This Service Information bulletin supersedes SI M71 01 15 **dated March 2015**.

Recall Campaign 15V-034: Replace Vehicle Identification Number (VIN) Label and Tire Label on Left B-Pillar

F56 (Cooper Hardtop 2-door)

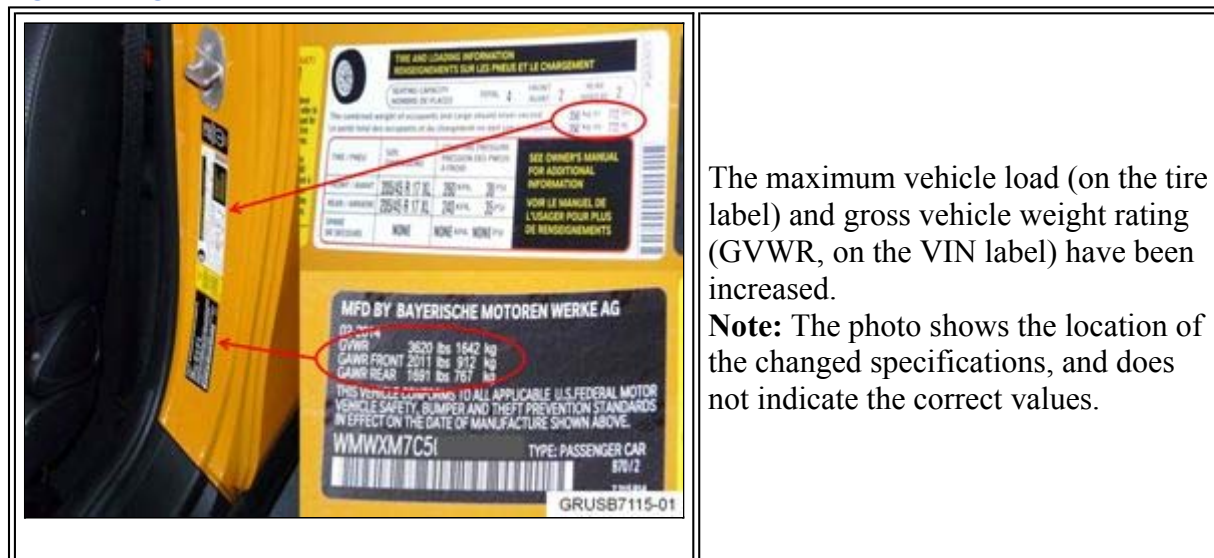
The gross vehicle weight rating (GVWR) displayed on the VIN label, which is affixed to the vehicle's left B-pillar, is too low.

The vehicle capacity weight value displayed on the tire label, which is affixed to the vehicle's left B-pillar, is too low.

The maximum vehicle load (on the tire label) and gross vehicle weight rating (GVWR, on the VIN label) have been increased.

Note: The photo shows the location of the changed specifications, and does not indicate the correct values.

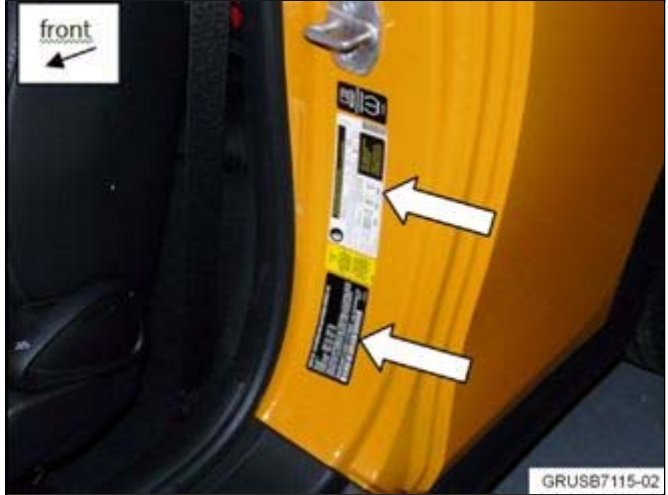
<p>Compare the new label versus the old label to verify that the VINs match and the GVWR is different (has increased) before the old label is removed! Remove the tire pressure label (upper arrow) and the VIN label (lower arrow) from the driver's B-pillar.</p> <ul style="list-style-type: none"> Carefully use a heat gun to soften the adhesive backing on each label. Remove the label with a plastic wedge. <p>Remove all adhesive residue from the B-pillar with an appropriate cleaner (brake cleaner, rubbing alcohol).</p>
---	--

Apply the new labels at the same position and with the same orientation as the original label.

- Press firmly on the entire surface and all edges for maximum adhesion.
